Product Change Notification

113138 - 00

Change Notification #: 113138 - 00
Change Title: Intel® Server Chassis P4216XXMHJC
PCN 113138-00, Product Design, Label
Update Front Panel Printed Circuit Board,
Front Panel Spare Transparent Window Size,
Power Button LED and Update Regulatory
Labels
Date of Publication: July 15, 2014

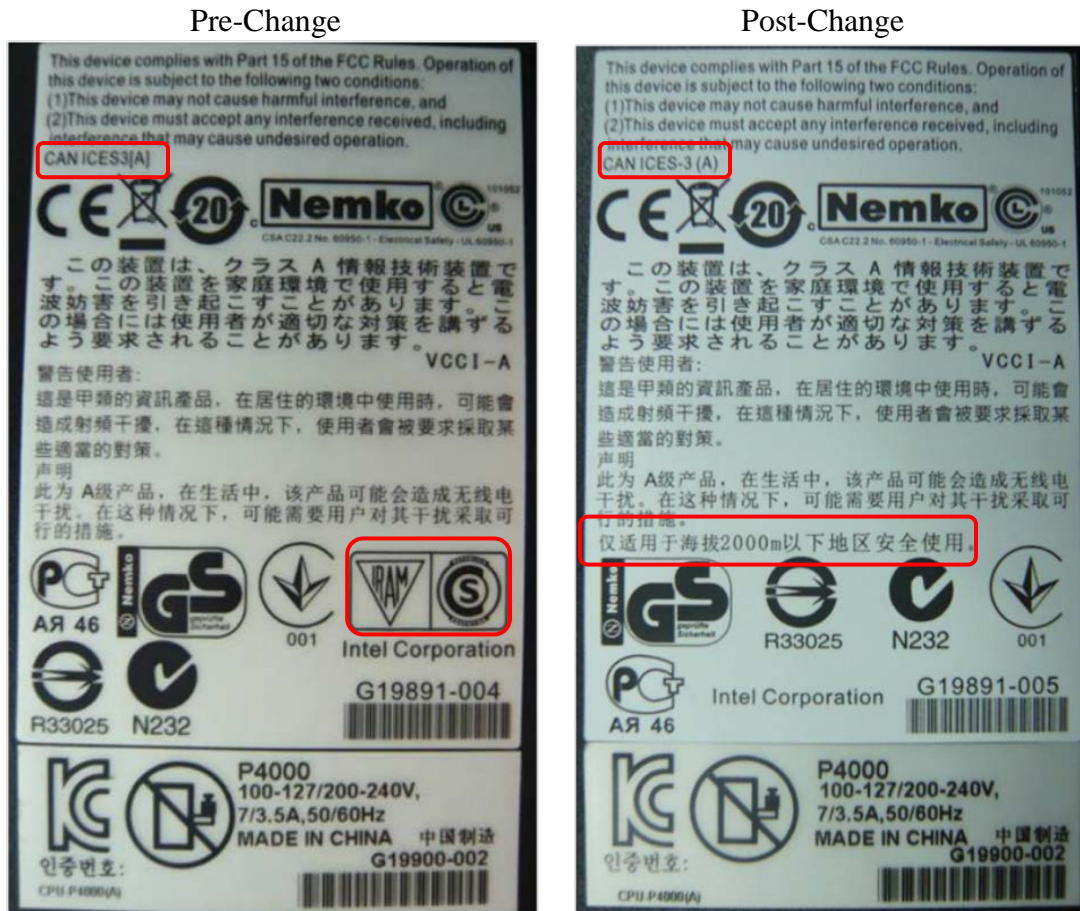
2. Change the power button cap icon outer diameter from 4.0mm to 3.5mm. The transparent area on the post-change button is more centralized than on the pre-change one. The purpose of this change is to make the button brighter. The post change button icon is smaller, but more of the icon area is directly illuminated by the LED.
